**Subject: Important Medical Device Information – INGEVITY™ MRI active fixation pacing lead manual - Ref. 92160868-FA**

### **Appendix A: Summary of INGEVITY Active Fixation Physician Lead Manual Updates**

**Table 1: Updates to INGEVITY MRI Active Fixation Physician’s Lead Manual**

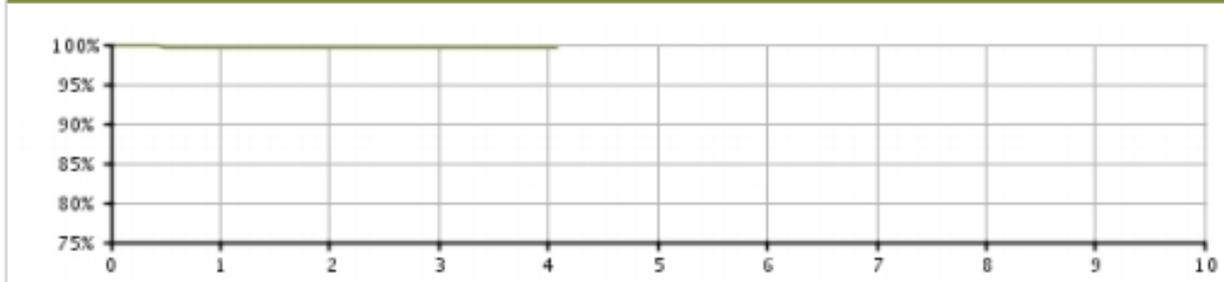
<b>Location in <i>Physician’s Lead Manual</i></b>	<b>Labeling Updates</b>
Information for Use: Precautions AND Implantation: Handling the Fixation Helix	<b>Do not overextend or over-retract the helix.</b> Do not overextend or over-retract the helix. The lead <b>conductor coil or fixation mechanism</b> can be damaged <b>or broken</b> if you continue to rotate the terminal pin once the helix is fully extended or retracted.
Information for Use: Precautions AND Implantation: Handling the Fixation Helix and Lead Fixation	<b>Avoid creating sharp bends while extending or retracting helix.</b> Avoid creating sharp bends in the lead terminal or lead body while extending or retracting the helix. <b>Sharp bends can increase the risk of breaking the conductor coil or fixation mechanism during helix extension and retraction.</b>
Information for Use: Precautions AND Implantation: Lead Fixation and Repositioning the Lead	<b>Terminal pin maximum number of turns.</b> Do not rotate the terminal pin clockwise or counterclockwise more than the recommended maximum number of turns indicated in the specifications (Table 5 Specifications (Nominal) on page 29). Continuing to rotate the terminal pin once the helix is fully extended or retracted (as indicated by fluoroscopy) can damage the lead, <b>cause a conductor coil break during fixation</b> , cause lead dislodgment, tissue trauma, and/or cause acute pacing threshold to rise.

Implantation / Handling the Fixation Helix section	NOTE: The expected <b>number of turns</b> and the recommended maximum number of turns to extend or retract the helix are provided in the specifications (Table 5 Specifications (Nominal) on page 29). Any curves introduced into the stylet could increase the number of turns needed to extend or retract the helix.
Implantation / Lead Fixation section	NOTE: The number of turns to extend or retract the helix may vary based on patient anatomy and implant conditions. <b>Maintain a straight trajectory coming out of the patient anatomy to the extent feasible.</b>
Implantation / Evaluating Lead Performance	Verify electrical performance of the lead using a pacing system analyzer (PSA) before attaching the lead to the pulse generator. <b>Verifying electrical performance will confirm lead integrity.</b> (Note: This is also proposed for the timed fixation manual.)

Implantation / Electrical Performance	• A discontinuous signal may indicate a lead <b>conductor coil break</b> , fracture or an otherwise damaged lead, or an insulation break that would necessitate lead replacement.
Specifications / Specifications table (Note this CAUTION statement was previously included in the manual and was added to this section of the PLM)	Recommended maximum number of rotations to extend/retract the helix <b>CAUTION: Do not rotate the terminal pin clockwise or counterclockwise more than the recommended maximum number of turns indicated. Continuing to rotate the terminal pin once the helix is fully extended or retracted (as indicated by fluoroscopy) can damage the lead, cause a conductor coil break during fixation, cause lead dislodgment, tissue trauma, and/or cause acute pacing threshold to rise.</b>
